RECEPTION SET R 206, MK. 2

TECHNICAL HANDBOOK - MODIFICATION INSTRUCTION

Prevention of break-through effect

Fig. 1 - Modified circuit diagram of output stage

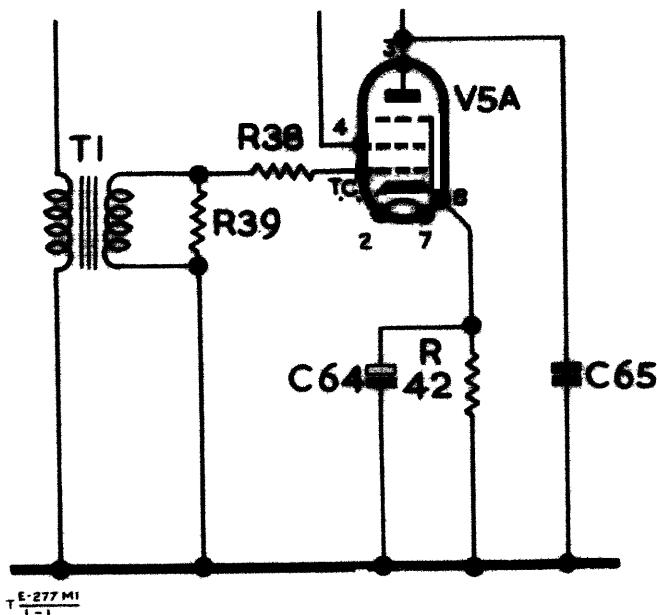
5. Remove the feedback circuit from the output stage, i.e., remove C66, R40 and R41.

6. Connect the earthy end of T1 secondary to chassis.

7. Disconnect the earthy end of R42 from the cathode bias line and connect it to chassis.

Fig. 2 - Modified circuit diagram of 1st R.F. amplifier

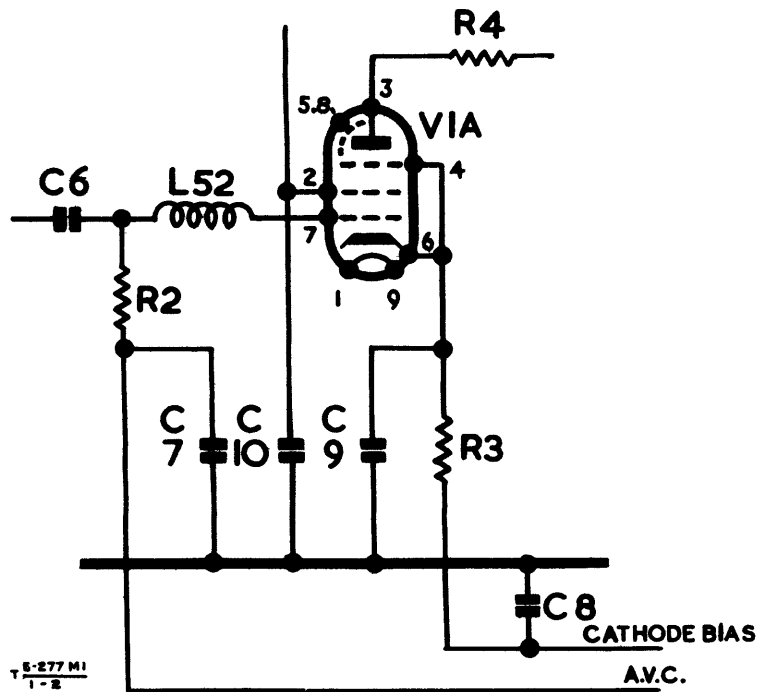
8. Remove R2. Replace R1 (2.2M $\Omega$ ) by R2 (220k $\Omega$ ).
